RECEIPT DATE: 11/13/25 **ONSITE SEWAGE DISPOSAL SYSTEM** P 590270

APPROVAL DATE: 2/2/26 **PERMIT: NEW CONSTRUCTION** A \_\_\_\_\_

PROPERTY ADDRESS: 1719 Brickell Way

**SEPTIC SYSTEM  
 INSTALLATION PLAN  
 BRICKELL PROPERTY**

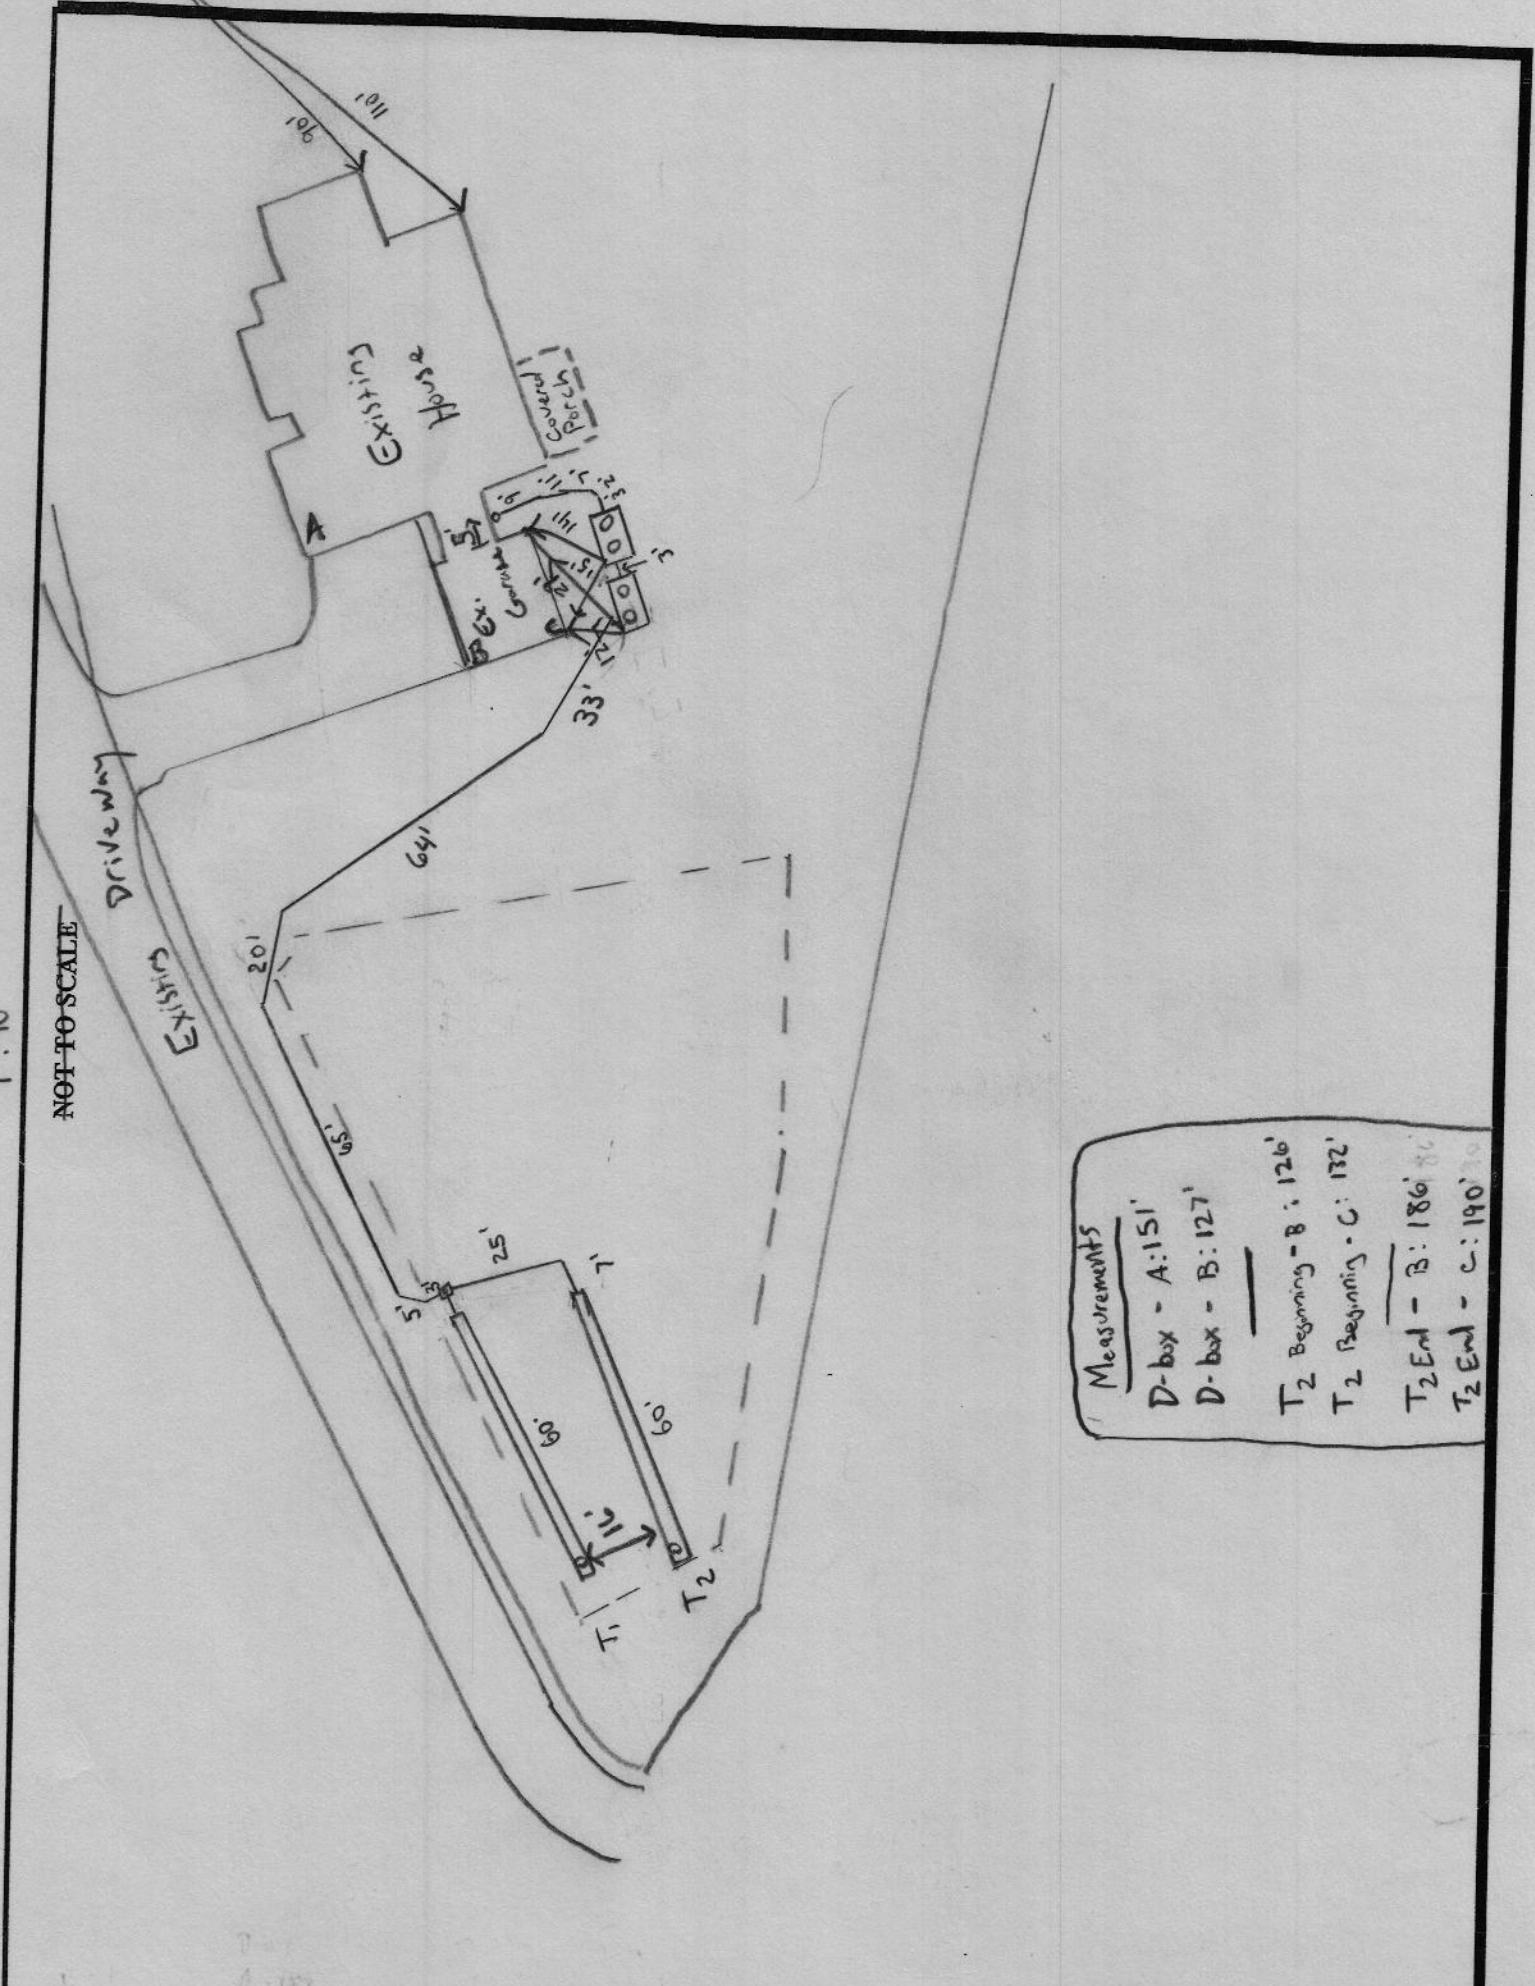
11/18/2025 - Installer onsite for inspection. PM running out of tank manhole. PM saw 40 ft pressure rated D-box installed w/ 90° turn down. Greater length @ 61, inlet @ 2'-2.5'. Distance between trenches 16'. Stone & fabric OK. ST has 4" baffle. OK to backfill all work. (SP)

11/14/25 Reviewed design plan with installer OR with tank locations. Will be shifting the d. box so that it is in front of trench 1. SDA, tanks and trenches are staked accurately per plan. Locations where trenches will be installed have a hump in the middle with the trenches having a 7" difference from the middle to the end. Per KW ok for 7" difference, contractor to keep trench bottom level and therefore deeper in the middle.

11/14/25 Tank hole and front line being dug while on site. Tank hole and front line has some large stones being excavated. (MB)  
11/14/25 PM inspection. Waiting for septic tank to arrive. Front line dug. Pipe is balled. SDC not made yet. Schedule 40 pipe used. Tank arrived & installed and is level. Front line is stepped in two places to make fall to ST. 6" baffle installed. OK to backfill tank hole. (MB)  
11/17/25 Pump tank delivered. Tank is level and has fall from ST to PT. Contractor to start trench. Stone being delivered. Stone is good. (MB)  
11/17/25 Contractor has d box and Trench 1 dug. Trench 1 has 2' inlets on ends of trench and 2.5' inlet towards center of trench. Geotextile fabric added along with observation port OK to backfill trench 2/2/26 - P&A OK. (MB)

**SEPTIC SYSTEM INSTALLATION PLAN**  
**BRICKELL PROPERTY**  
LOT 3  
(1719 BRICKELL WAY)  
ZONING: RR-DEO  
GRID No.: 274  
THIRD ELECTION DISTRICT HOWARD COUNTY, MARYLAND  
SCALE: AS SHOWN DATE: JUNE, 2025  
SHEET 1 OF 2

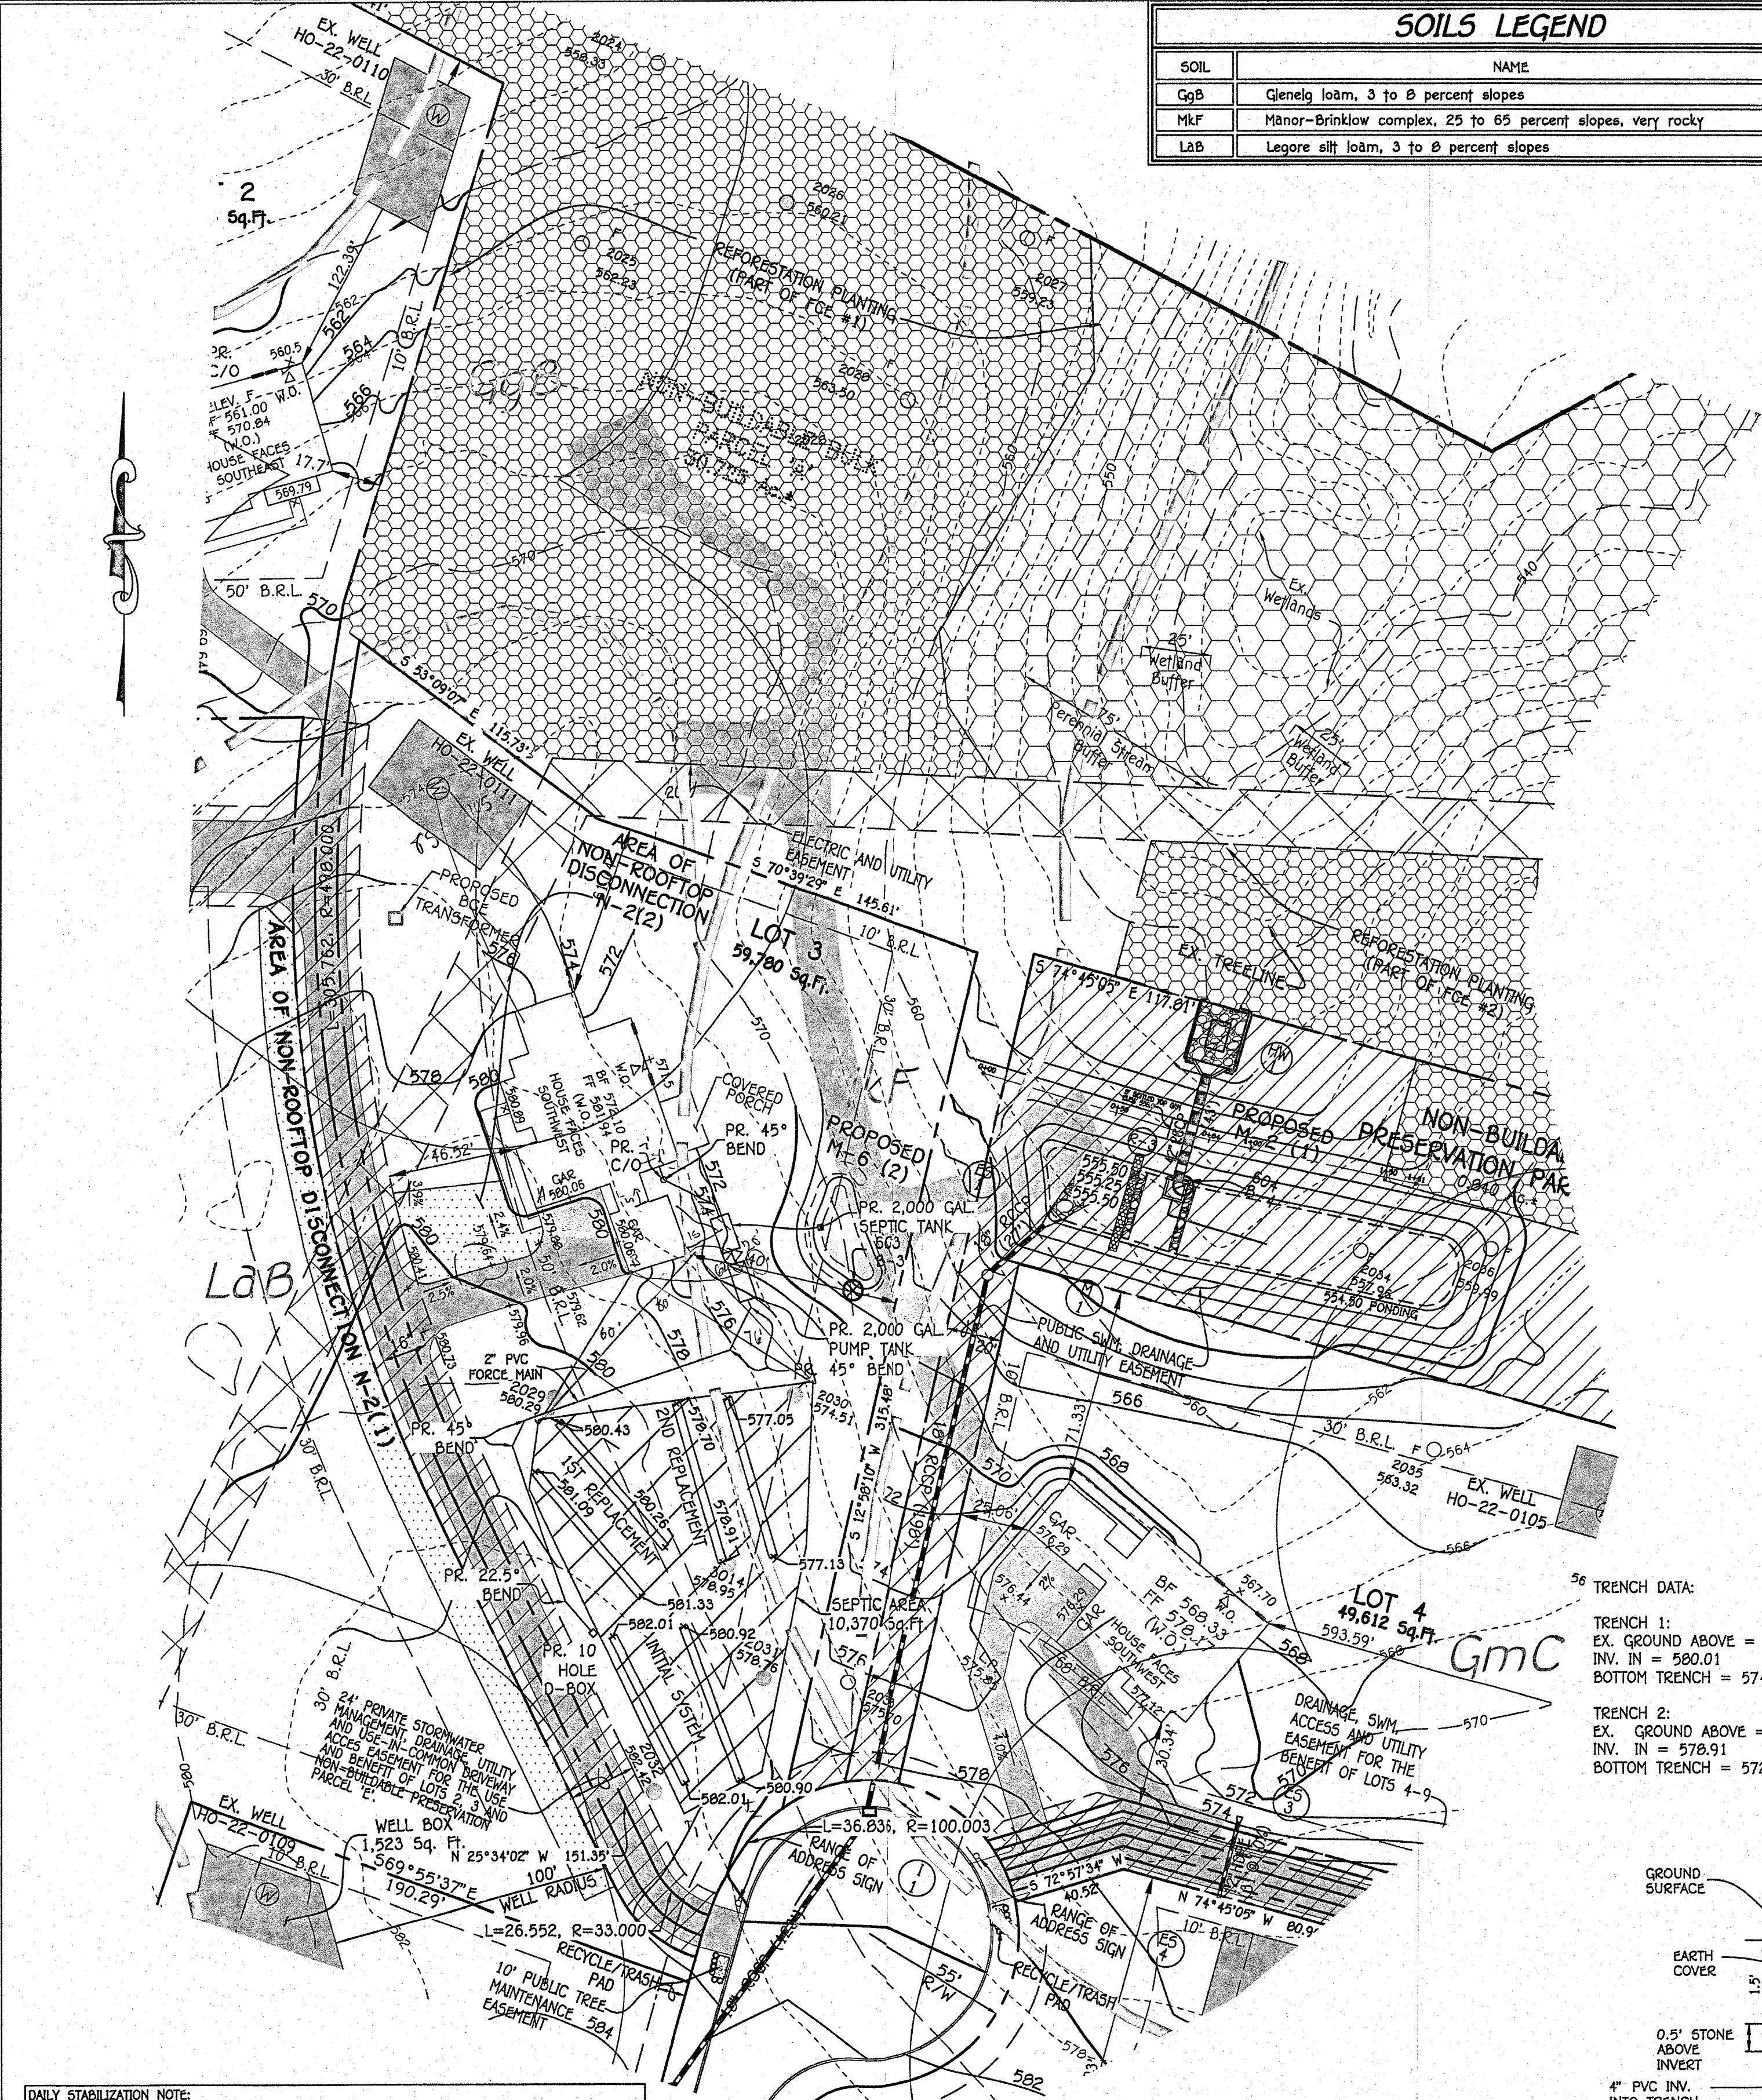
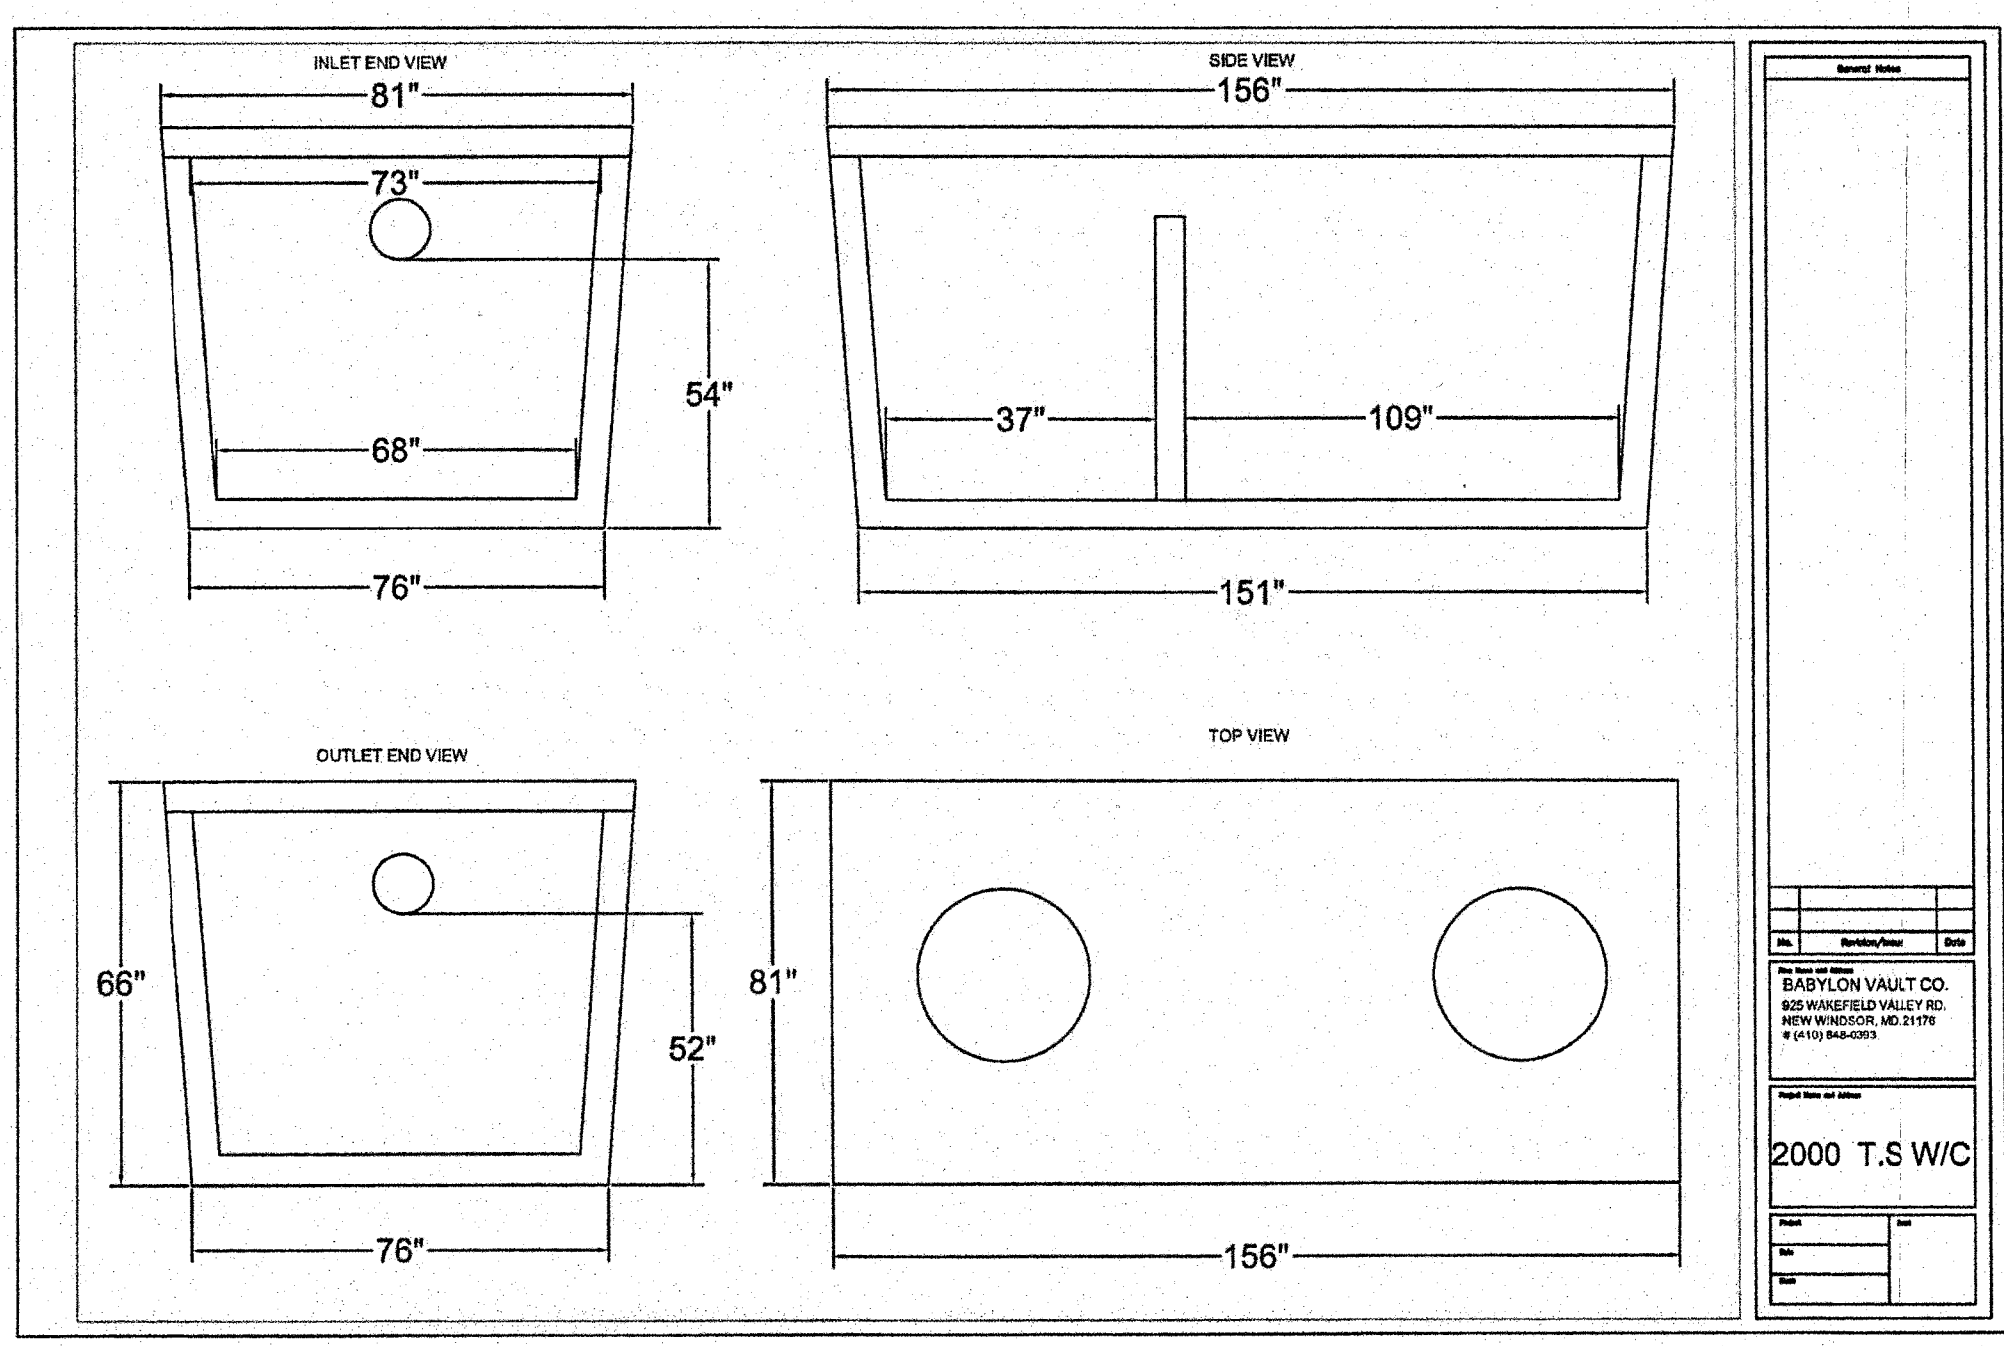
B25005267 – 1719 Brickell Way – the plan isn't showing the onsite septic system for the property and the proposed location for the lp tank on the plan you submitted is in close proximity to the septic tanks. Please get the septic tanks and setback on the plan and resubmit.
